SUBJECT: TECHNICAL SPECIFICATION CHANGES TO ALLOW OPERATION WITH ONE
RECIRCULATION LOOP AND EXTENDED OPERATING DOMAIN

RE: GRAND GULF NUCLEAR STATION, UNIT 1

MISSISSIPPI POWER & LIGHT COMPANY
MIDDLE SOUTH ENERGY, INC.
SOUTH MISSISSIPPI ELECTRIC POWER ASSOCIATION
DOCKET NO. 50-416
GRAND GULF NUCLEAR STATION, UNIT 1
AMENDMENT TO FACILITY OPERATING LICENSE

Amendment No. 16
License No. NPF-29

FIGURE 3.2.1-2 MAPFAC_f

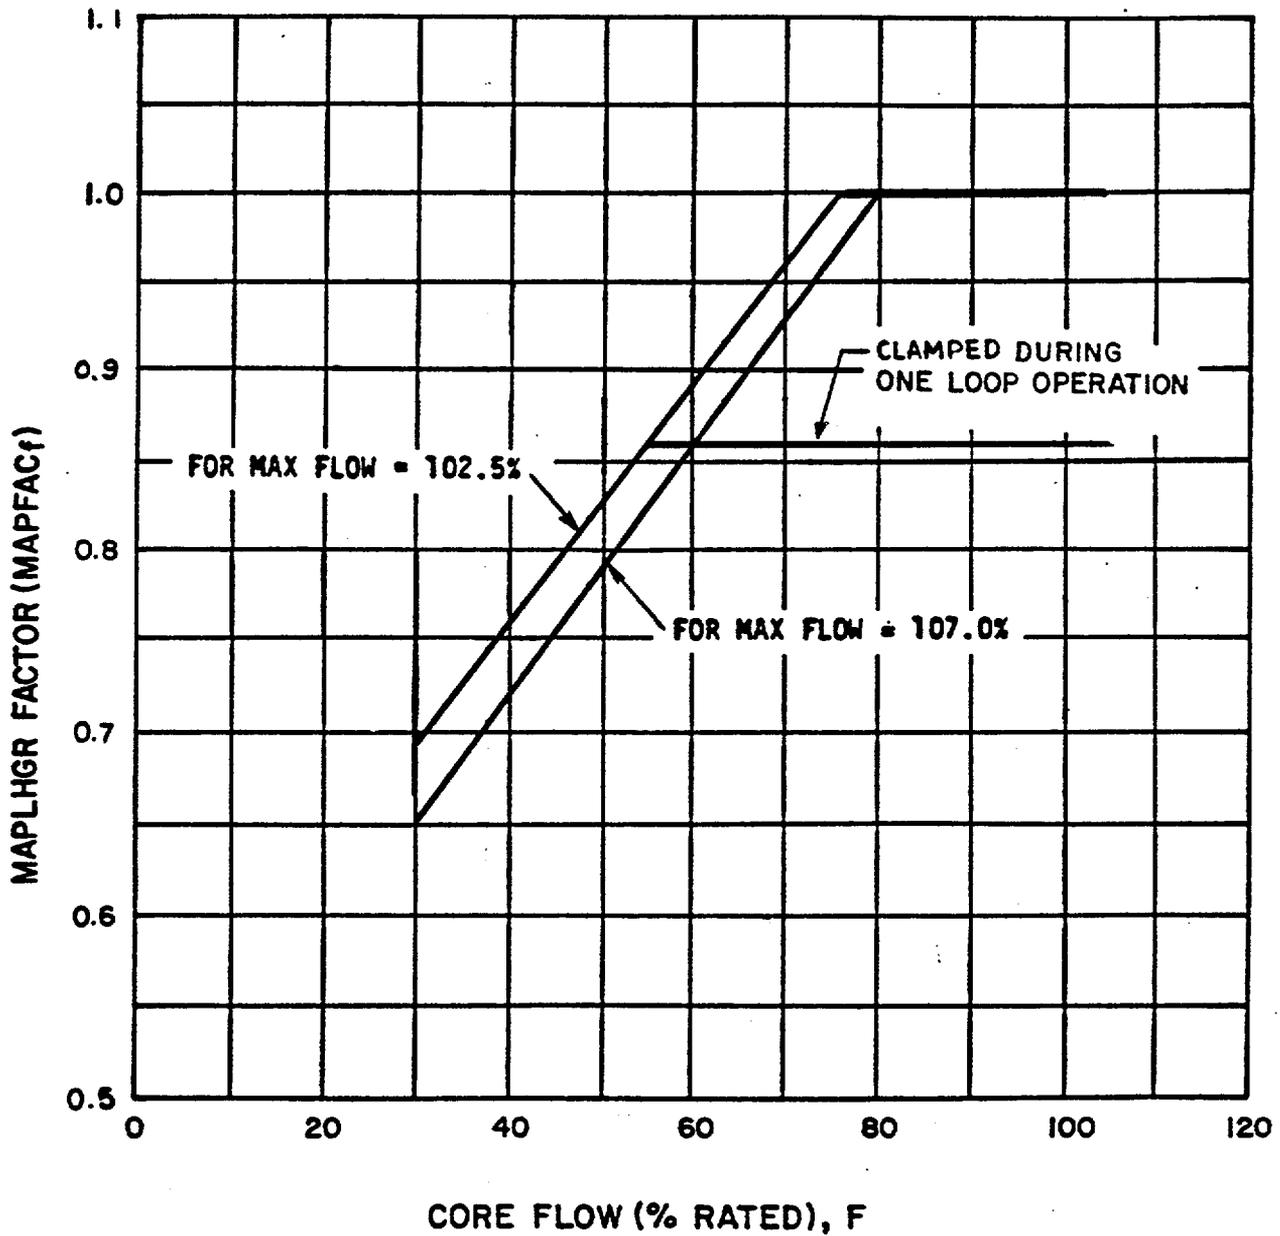
(4) Specification 3/4.2.1. MAPLHGR will be multiplied by the smaller of either the flow-dependent MAPLHGR factor ($MAPFAC_f$) of Figure 3.2.1-2, or the power dependent MAPLHGR factor ($MAPFAC_p$) of Figure 3.2.1-3. This is acceptable.

FIGURE 3.2.3-1 MCPR_f

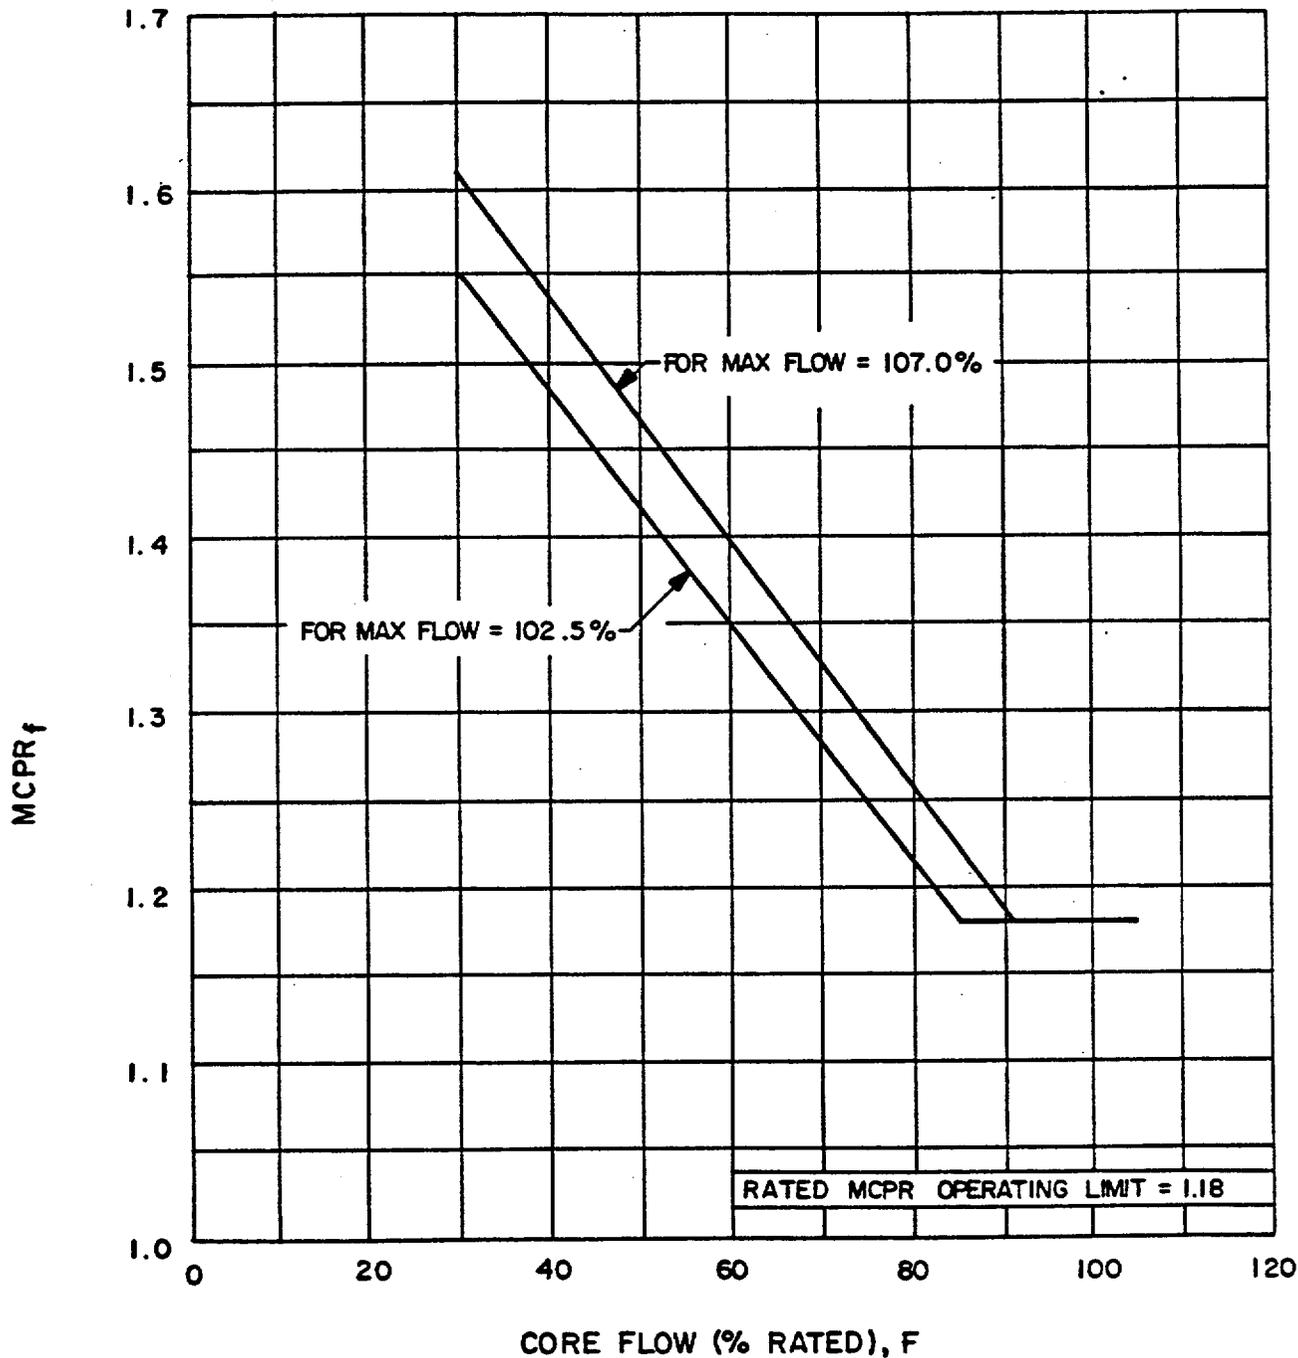
results in new flow dependent MCPR limit curves. The new curves, shown in Figure 3.2.3-1, are slightly above the curve in the current Technical Specifications. The new set of power dependent MCPR limits shown in Figure 3.2.3-2 result from elimination of APRM setdown. The new limits include the effect of operation at feedwater temperature reductions up to 50° F. The operating limit MCPR at any power/flow condition is the larger of the new flow and power dependent values. We find the proposed changes acceptable.

FIGURE 3.4.1.1-1 POWER-FLOW OPERATING MAP

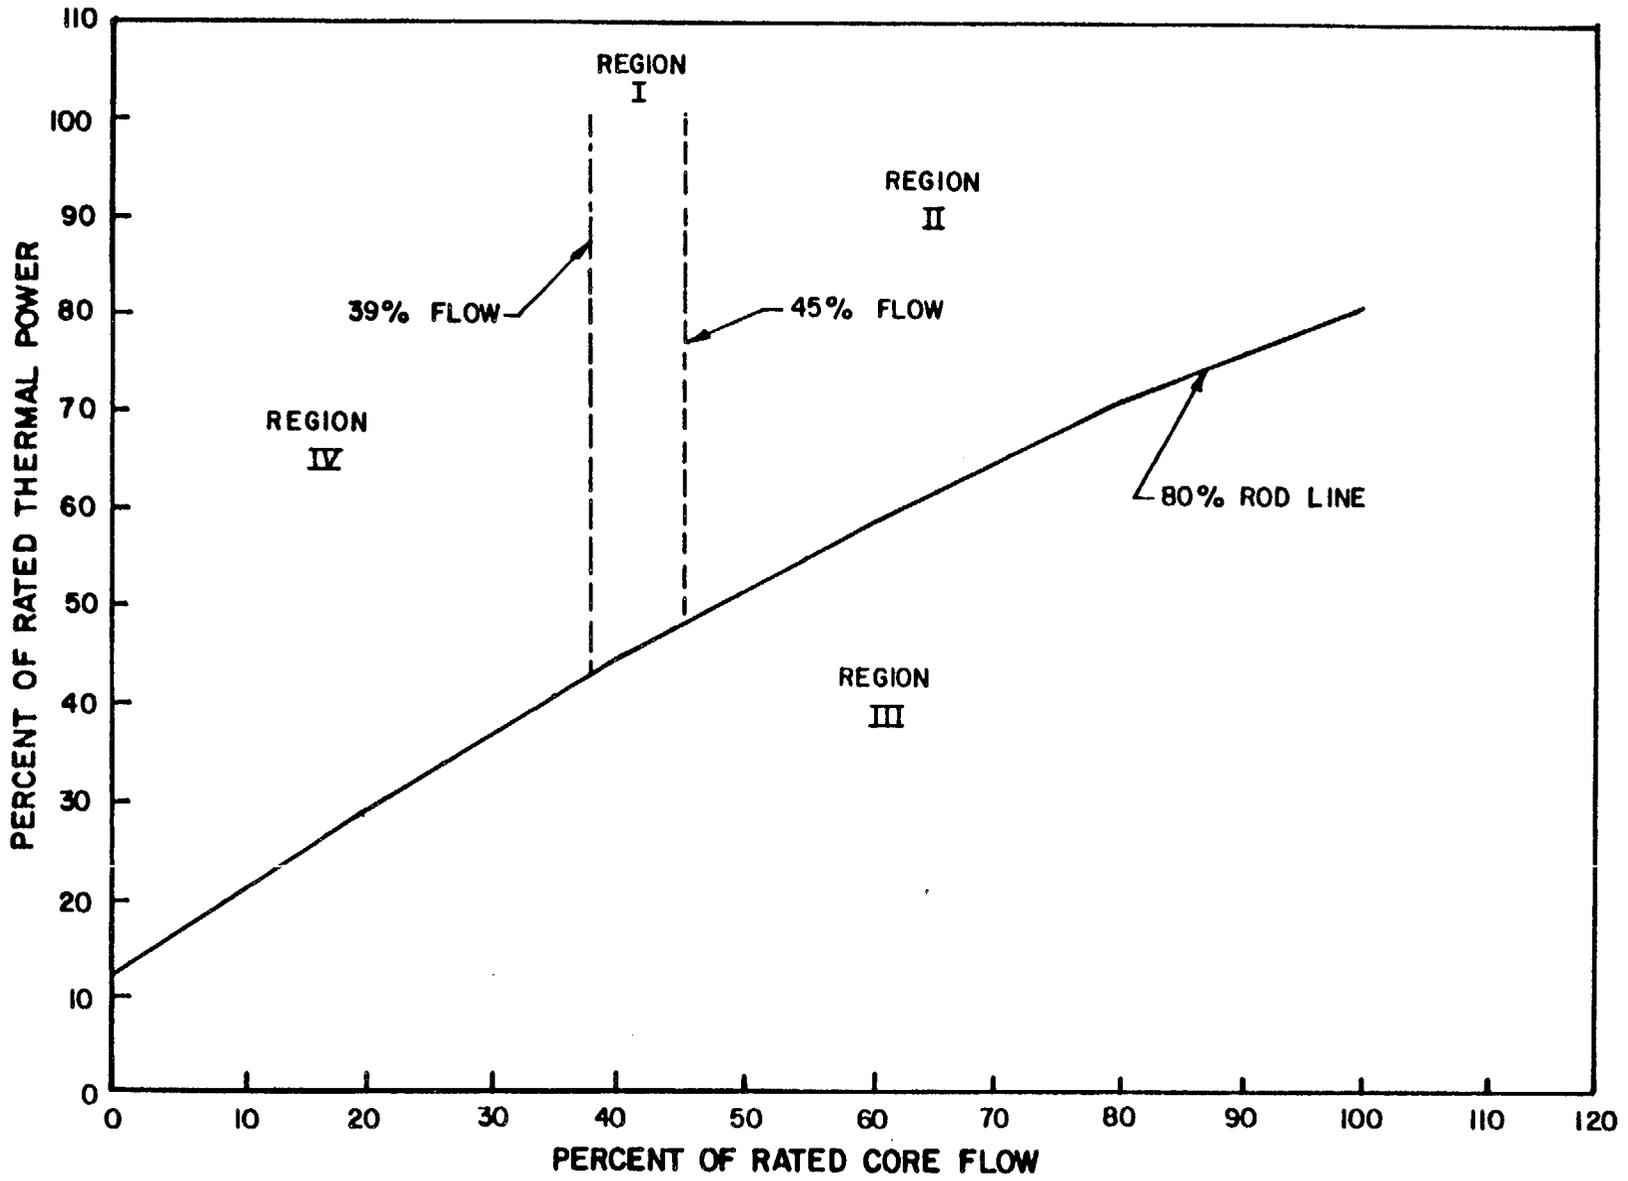
- e. With operation in Region IV as specified in Figure 3.4.1.1-1, initiate corrective action within 15 minutes to either reduce power to within Region III of Figure 3.4.1.1-1 or increase flow to within Region I or Region II of Figure 3.4.1.1-1 within 4 hours.

Stability tests at operating plants were reviewed to identify a region of the operating map where surveillance should be performed. To account for variability, a conservative decay ratio of 0.6 was chosen as the basis for defining the region of potential instability. The resulting region corresponds to core flow less than 45% of rated and THERMAL POWER greater than the 80% rod line. The 80% rod line is illustrated in Figure 3.4.1.1-1.
